UNITED STATES PATENT AND TRADEMARK OFFICE

Office Action Summary

10/724,890

DETAILED ACTION

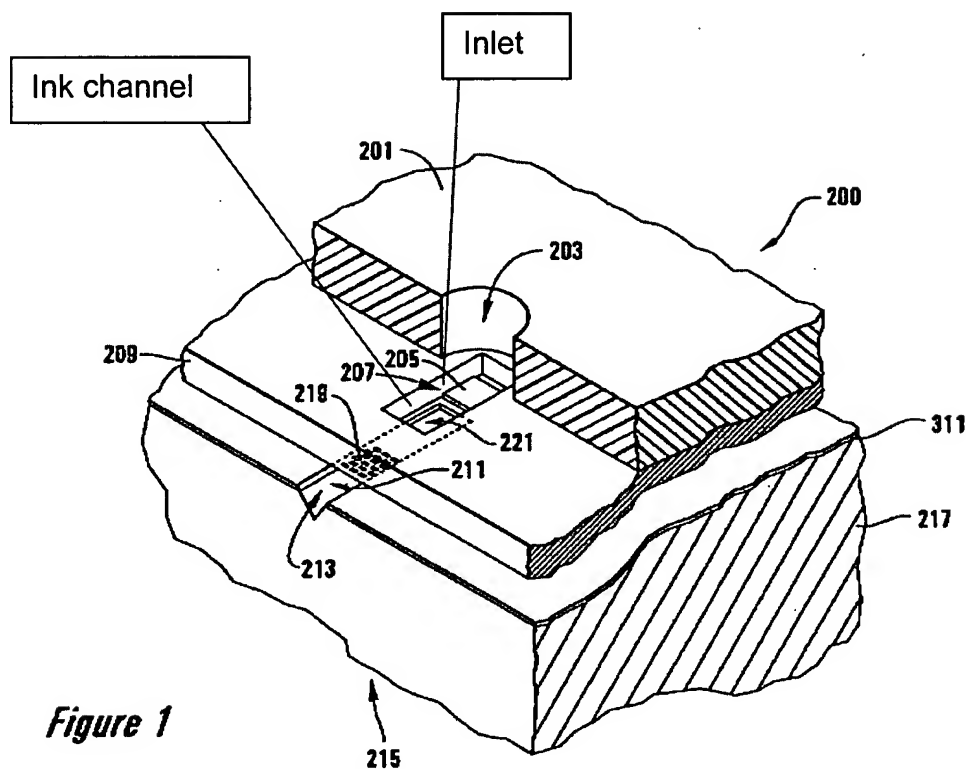
With respect to claim 1, Chee teaches:

- A silicon substrate (217)[see col. 4:42] having a plurality of heaters (205) and a main ink supply channel (215) that is connected to a cartridge (col. 2:58).
- A first barrier layer (209) has a plurality of firing chambers (207) at positions corresponding to the heaters and a plurality of ink channels that

are connected to the firing chambers and the main ink supply channel by inlets, as shown above.

- A second barrier layer (311) having a plurality of slots (213) extending from the main ink channel to the inlets of the ink channel. As can be seen in Fig. 1, the heater is located on the second barrier layer, thus the second barrier layer covers the bottom of the ink chamber.
- A nozzle plate (201) covers the first and second barrier layers and has a plurality of nozzles (203).
- The first barrier layer is located between the nozzle plate and the second barrier layer.

With respect to claim 4, the second barrier layer has a plurality of holes (219) corresponding to the nozzles.
